Panel Report

**Whittlesea and Mitchell Planning Schemes Amendment
GC28
Donnybrook/Woodstock Precinct Structure Plan**

8 September 2016

Panel Report pursuant to Section 25 of the Act

Figure 3: Revised Version of Lockerbie East DSS (Document 10)

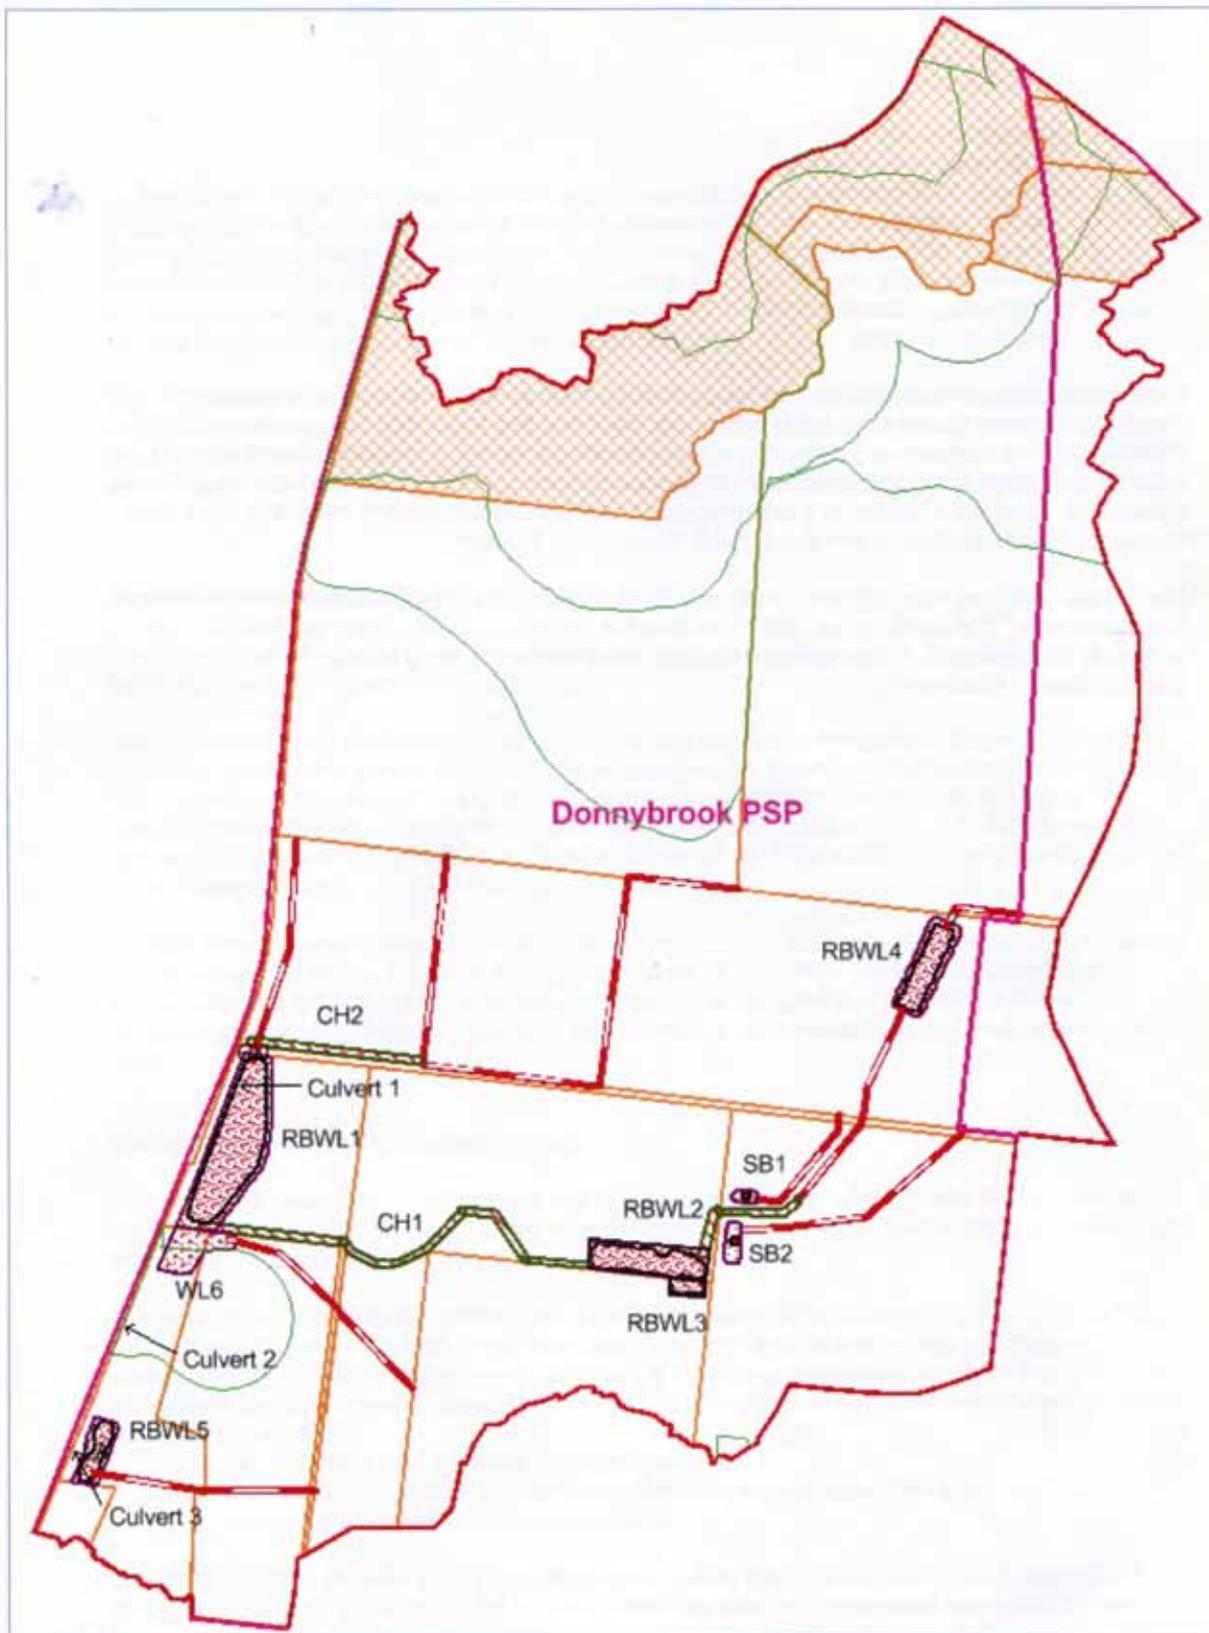
The exhibited DWPSP was based on a version of the Lockerbie East Development Services Scheme (DSS) that has been superseded. The Hearing proceeded on the consideration of a revised DSS (Hearing Document 10) which is shown in Figure 3. In reports and evidence during the course of the Hearing, expert witnesses recommended two changes to the revised DSS:

- rationalisation of the three pipes flowing into RBWL2, SB1 and SB2 south of Cameron Street
- removal of Catchment 5 (as shown in figure 4, page 8, of the May 2016 Expert Witness Statement by Mr Jonathan McLean) from the DSS and the inclusion in the PSP of a 1.7 hectares wetland drainage reserve in Catchment 5.

The issue is whether the constructed open channel waterways in the revised Melbourne Water Lockerbie East Drainage System Scheme (see Figure 3) can and should be replaced by pipes.

Modify and undertake further investigation to refine the revised version of Melbourne Water's Lockerbie East Development Services Scheme (Hearing Document 10 included as Figure 3 in this report) as follows:

- **Remove Catchment 5 (as shown in figure 4, page 8, of the May 2016 Expert Witness Statement by Mr Jonathan McLean) from the Development Services Scheme**
- **Melbourne Water to further investigate the rationalisation of the number of pipes flowing into RBWL2, SB1 and SB2 south of Cameron Street. This work should include whether the small section of open channel in this part of the Development Services Scheme should be replaced with a pipe (see section 9.2 below).**
- **Melbourne Water and Metropolitan Planning Authority to determine the required changes to the Donnybrook/Woodside Precinct Structure Plan to include a 1.7 hectares wetland drainage reserve in Catchment 5.**

The Panel concludes that Melbourne Water’s revised DSS as shown in Figure 3 of this report is an appropriate outcome in terms of the size and location of RBWL2 and RBWL4.

Figure 4: Engeny Proposed Option 2 Drainage Scheme Layout for the Lockerbie East DSS

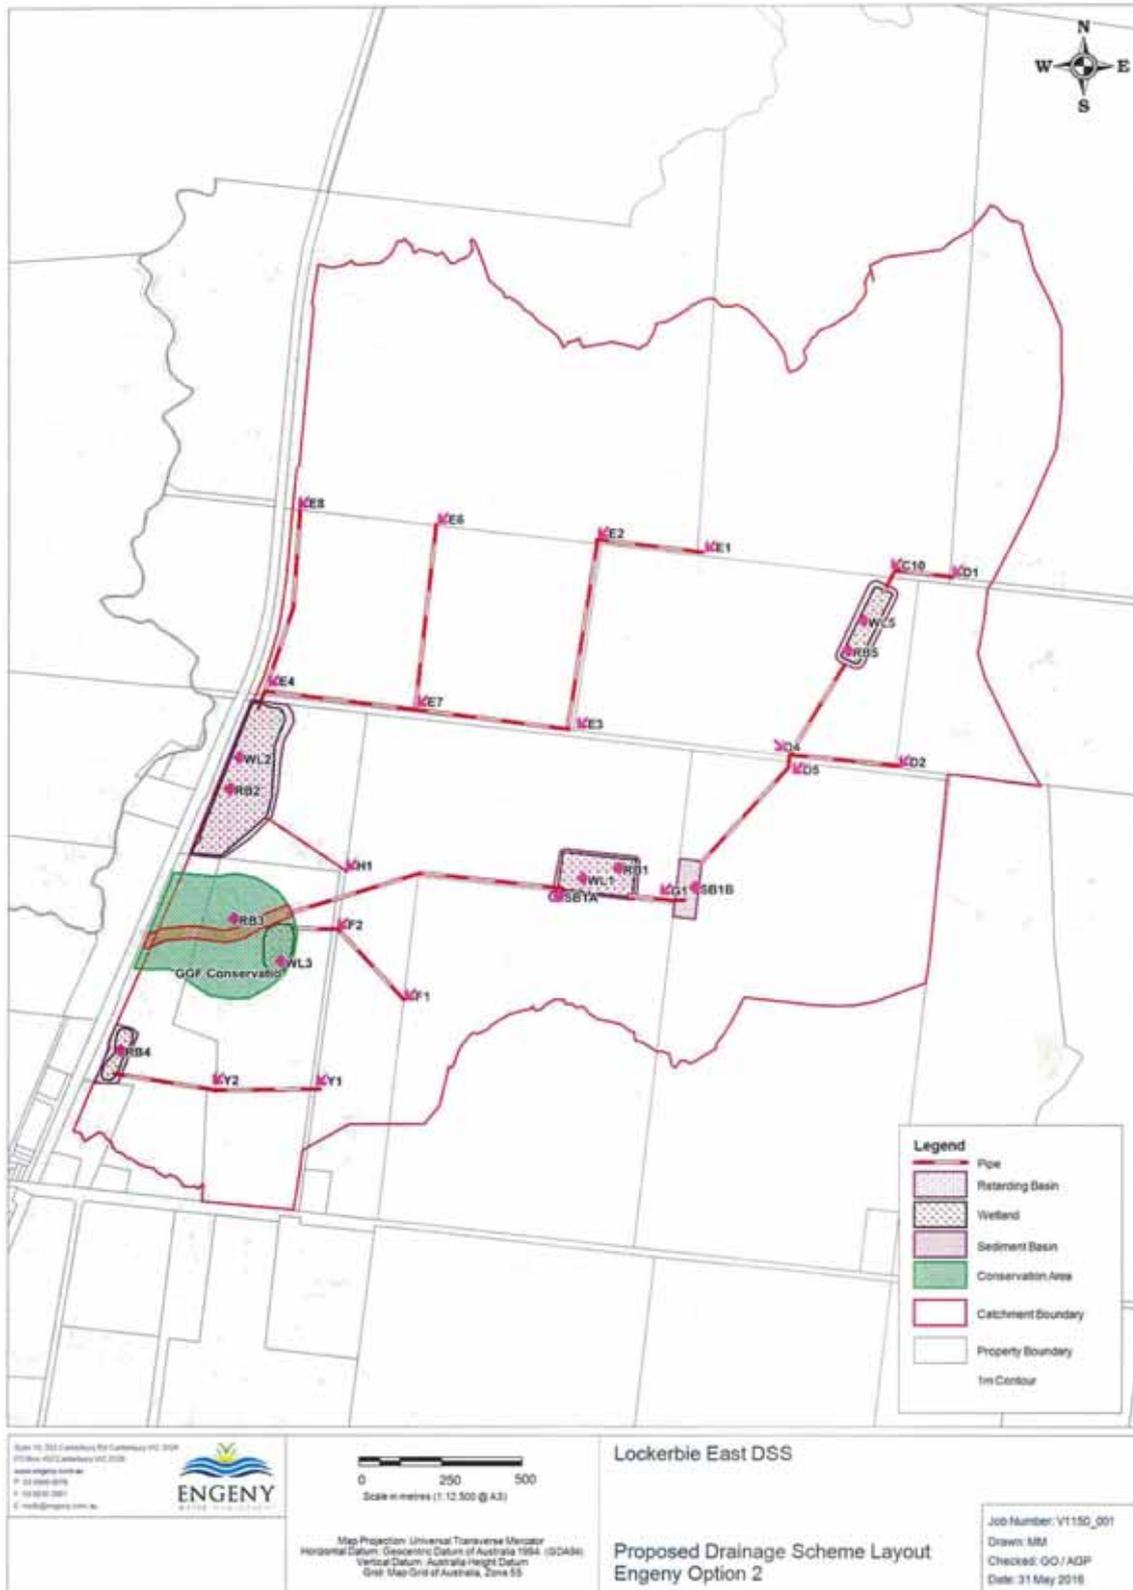
Mr Prout put forward an alternative piped drainage scheme (see Figure 4).

Mr Prout stated in his evidence that when applying the Melbourne Water DSS Guidelines to a catchment the size of this drainage scheme, a natural or constructed waterway is required for several reasons. He argued, however, that in this case none of those reasons applied. He

In his expert witness statement, Mr Prout (Energy Water Management) proposed an alternative drainage scheme in and around the Monteleone property. One aspect of this alternate scheme (see Figure 4 and Section 9.2 above) was a drainage pipeline flowing into a wetland within Conservation Area 34. Mr Prout stated that this area was the natural low point in the landscape and would be subject to flooding as shown by flood modelling. He suggested that the area could be managed to accommodate some stormwater treatment and serve as a retarding basin.

Figure 5: 'Existing Floodplain' for a tributary of Merri Creek

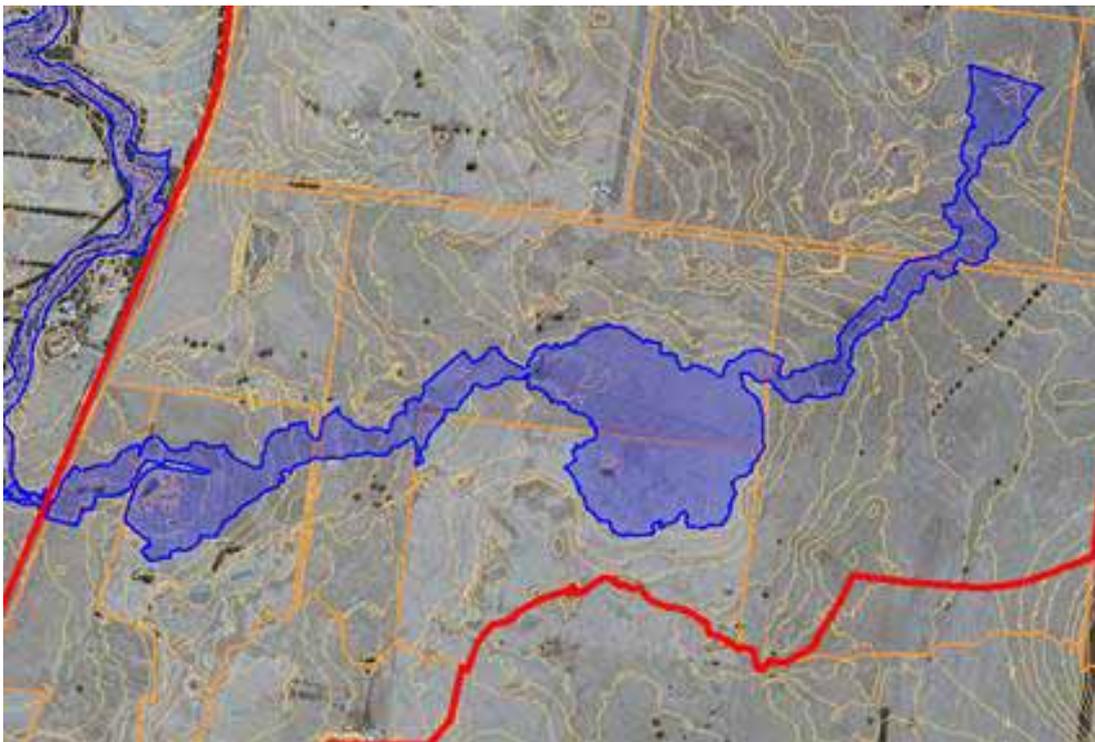
In her opening submissions, Ms Patterson stated that there is an 'existing floodplain' for a tributary of the Merri Creek which shows a clear flow path for drainage across multiple properties (See Figure 5 – Extract from page 39 of MPA Part B submission).

Ms Patterson submitted that:
